SERVICE BULLETIN

Number: SB0502

Subject: Hydro Lines on 52K23X

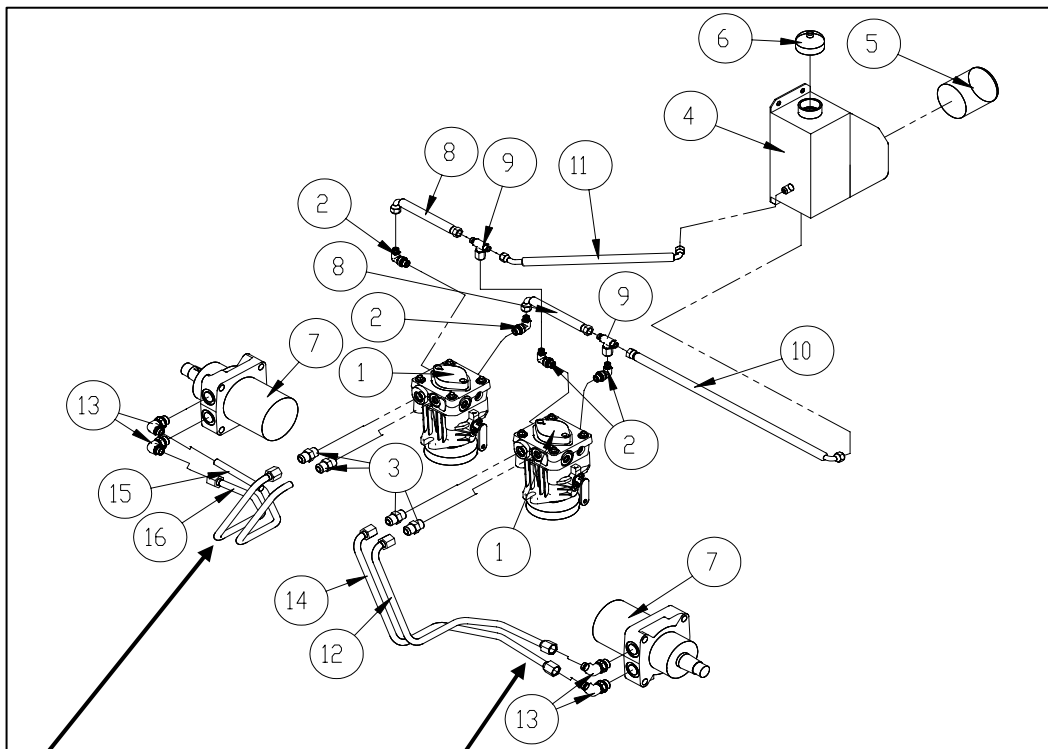
Details: Concerning the 52K23X, the two lower steel hydraulic lines have been changed to rubber lines on units with serial # 51622 and above. The two steel lines that are being replaced are:

533015 RH Outside Line (item #16 below)

533012 LH Inside Line (item #14 below)

5330015 - RH OUTSIDE LINE *

533012 - LH INSIDE LINE *

The new replacement rubber hydraulic line is part # **533113**. Below is a diagram indicating the two steel lines now being replaced by the 533113 rubber hydraulic line.

* Now being replaced by the 533113 - Rubber Hydraulic Line
